# SERVICE PLUS TECHNICAL BULLETIN

**Service Plus Group:** 09-06-0605

**Subject:** Air Conditioning is Not Cold Enough (Replace Condenser)

**Model:** 2002 Buick Rendezvous  
2001-2002 Chevrolet Venture  
2001-2002 Oldsmobile Silhouette  
2001-2002 Pontiac Aztek, Montana

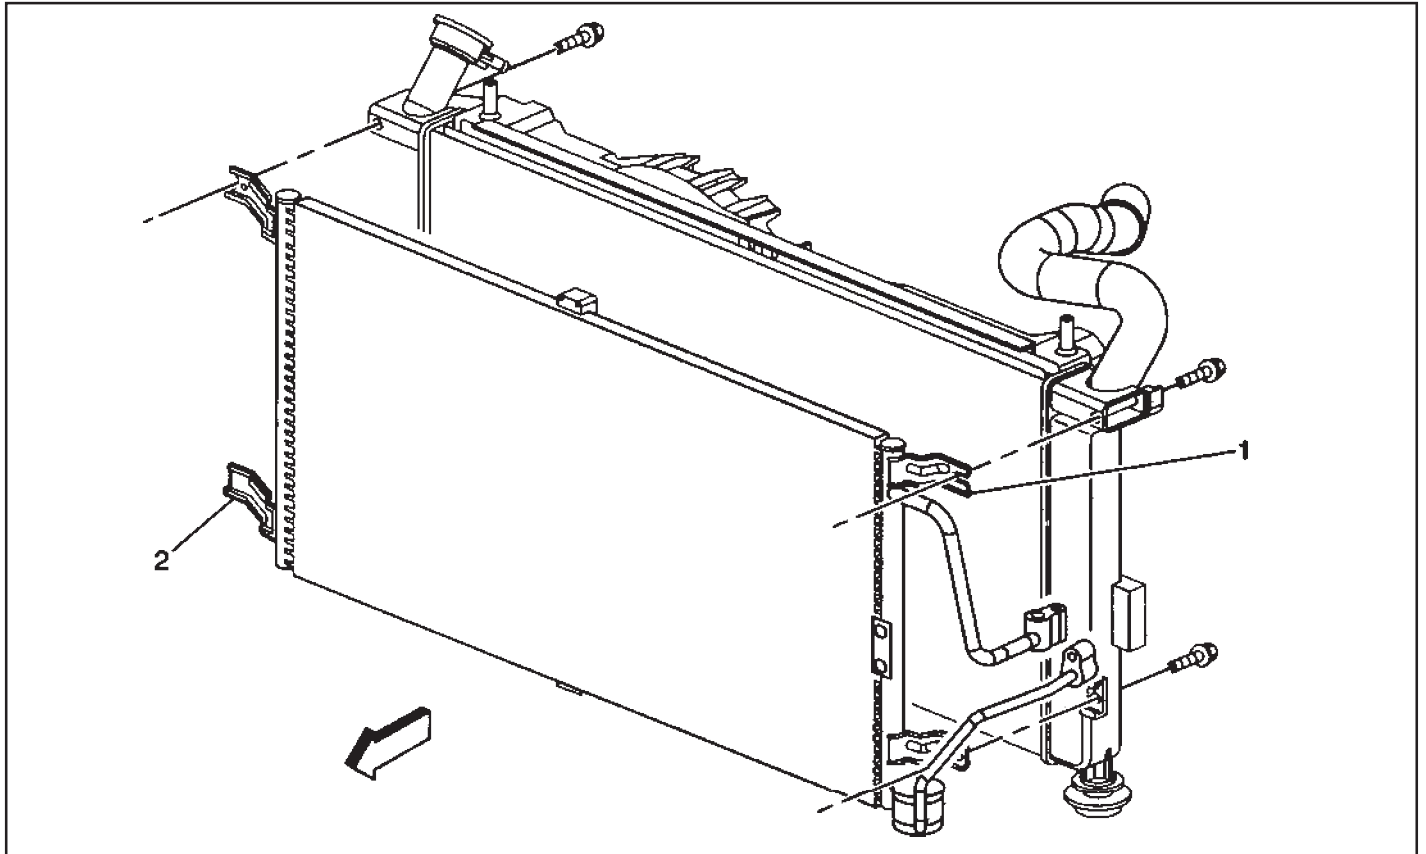
Some customers may comment that the HVAC (Heating, Ventilation and Air Conditioning) system does not get cold enough. You may find that the condenser is cracked and leaking at the lower right attachment bracket.

3. Refer to (1) and (2) in the illustration on the next page to find the locations where the condenser to radiator mounting will be changed.
4. At (2), (lower right attachment bracket), the new condenser will not have a hole in the bracket. Discard the bolt and J-nut that was used at this location with the original condenser.

5. At (1), (upper left attachment bracket), install a new J-nut, P/N 10335492, on the slotted condenser attachment bracket. Reuse the bolt that was in this location with the original condenser.

To correct this problem, replace the condenser with an updated design part. Use the following procedure to install a new condenser and modify the way the condenser is mounted to the radiator in the vehicle.
